Comments and Response Report – Pre-Consultation

The Proposed Development of a Primary Dwelling and Access Road on Portion 79 of Farm 205, Ruygte Valley, Sedgefield, Western Cape

COMMENTS	RESPONSE
COMMENTS RECEIVED IN RESPONSE TO THE PRE-CONSULTATION	DRAFT BASIC ASSESSMENT REPORT – <u>21 May 2025 – 23 June 2025.</u>

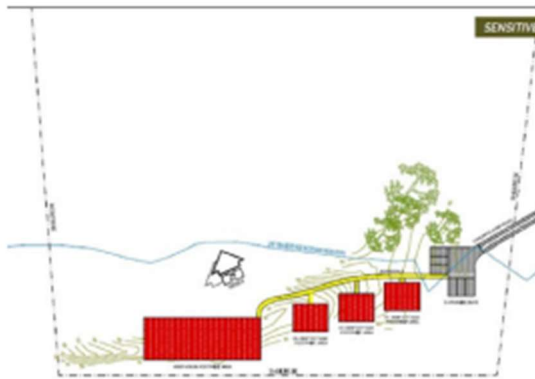
58. This accords with the applicant's other reports, for instance see Figure 12 at Page 25 of Appendix D4 Terrestrial Biodiversity Assessment:

7.4. SITE PHOTOS

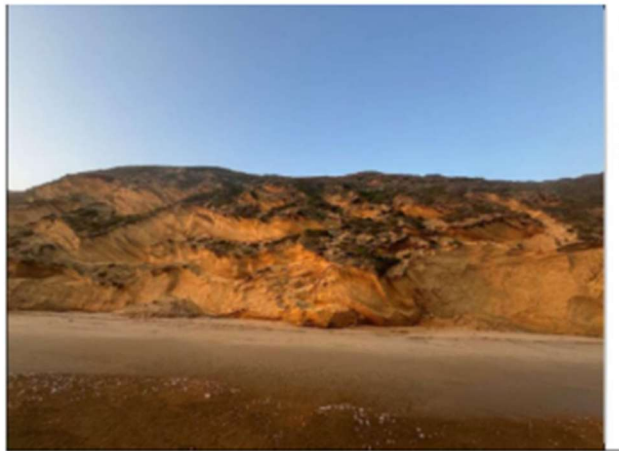
75.2. The next three photographs are all on the northern side of the foredune. They really add nothing of value about the main issue, the view from the coast.

75.3. The three pictures that follow, were all taken from behind bushes. I cannot ascertain at what height they were or where on the property they were taken.

We know that the beach is visible from the construction site, but this has not been shown. Neither were photographs taken at the height of the proposed structures, on an elevated platform, six metres in the air. The photographs really add nothing of value about the main issue, the view from the coast.

ID	15
Remarks	KOP beach 2 visual intrusion highly likely
Time	10/22/2024 12:08:34.999 GMT+02:00
Geometry	POINT Z (22,82513189 -34,04219157 35,053)
PhotoDir	NW
Photo	Ruygtevieu_20241022_120914554.jpg

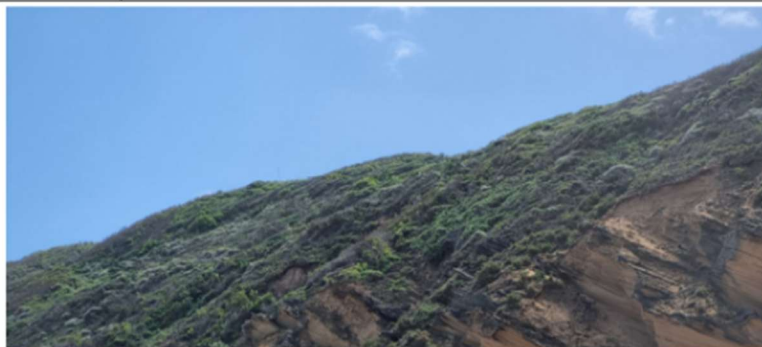
38 Mr Stead's photograph 15 shows visibility from the beach, as I interpret them.

39 If my understanding is correct, the version that the development would not be visible from the beach is a shockingly wrong, placing the whole BAR process in doubt. It is one of the most important issues in the matter. It is common cause that the visual impact study relied upon in the Third BAR is inaccurate. I would

The comment is noted.

Fig. 3. Site Constraints Map, showing SDP, Planning Space, 31 January 2026, amended DBAR

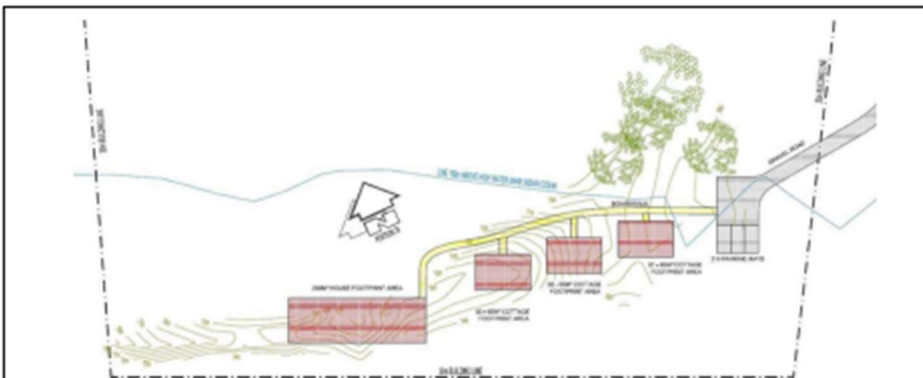
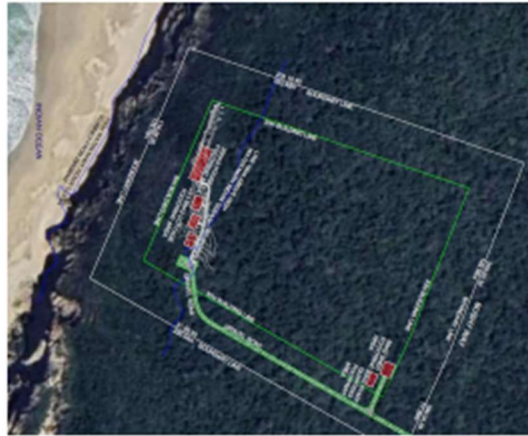
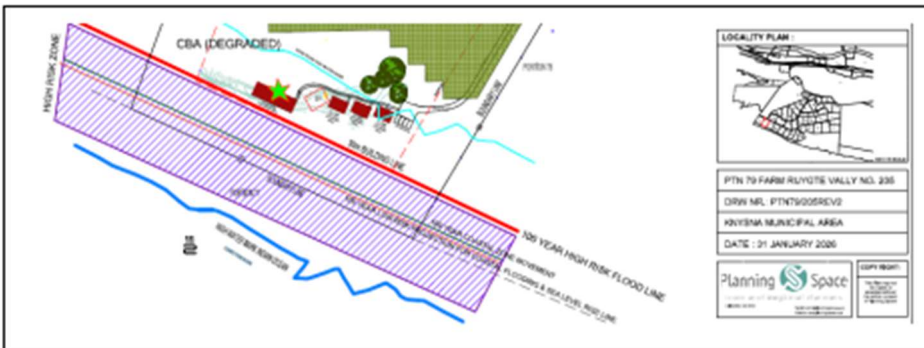
The total development footprint area of the preferred alternative has increased from that stated in the DBAR of November 2025 of approx. 1175m², to approx. 1375m² in the amended DBAR of January 2026.

An updated Constraints Map (Appendix B1) (**Fig. 3**), however shows a slight change to the SDP contained in the DBAR of November 2025 (**Fig. 1**). The three cottages appear to have been shifted slightly eastwards, however not northwards.
